Board of Zoning Adjustment Staff Report

December 17, 2018

Case No:	18CUP1070
Project Name:	Modification
Location:	2208 & 2210 Beargrass Avenue
Owner/Applicant:	Cardinal One Properties, Bruce Mattingly
Jurisdiction:	Louisville Metro
Council District:	10 – Pat Mulvihill
Case Manager:	Steve Hendrix, Planning & Design Coordinator

1973 CUP Site Plan

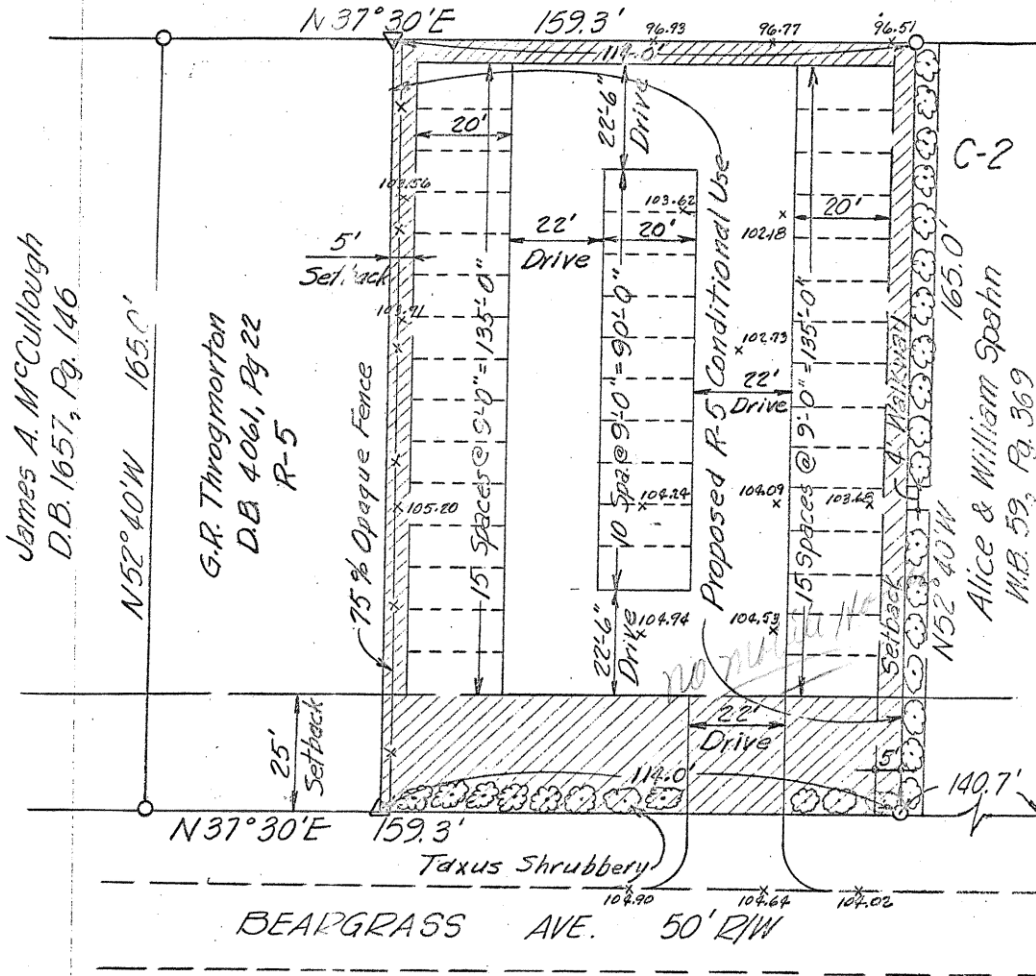
The approved site plan for the Off-Street Parking Conditional Use Permit in 1973 shows a 25 foot setback from Beargrass Avenue with shrubbery, a 75 opaque fence along the northern residential boundary, 40 parking spaces and a 4 foot walkway. Staff's site visit did not reveal those conditions.
